SUBJECT: Forwards corrected Figure 15.6.2-10 from Westinghouse rept discussing LOCA analysis in support of 880507 requested

SERIAL: NLS-88-129

H. B. ROBINSON STEAM ELECTRIC PLANT, UNIT NO. 2 DOCKET NO. 50-261/LICENSE NO. DPR-23 SUBMITTAL OF CORRECTED INFORMATION

FIGURE 15.6.2-10

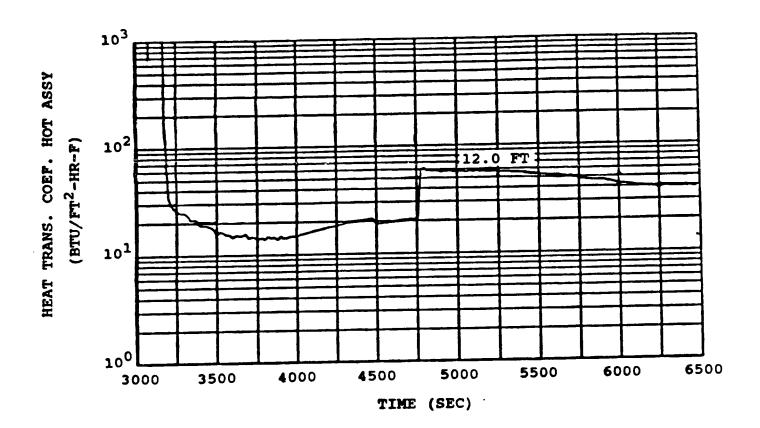
Carolina Power & Light Company's (CP&L) license amendment request dated May 7, 1988 transmitted a supporting report by Westinghouse Electric Corporation discussing the small break loss-of-coolant accident analysis (CPL-88-538, dated May 5, 1988). The continuing review by CP&L led to discussions with Westinghouse regarding the correctness of the Figure 15.6.2-10 included therein. It was discovered that due to an administrative error, the wrong plot was included in the report. The correct Figure 15.6.2-10 for the 1.5-inch break is attached. Please note that this is an administrative error only and does not impact the calculations or the results of the analysis. The other figures and information transmitted in the referenced report were checked, and we have found no other errors.
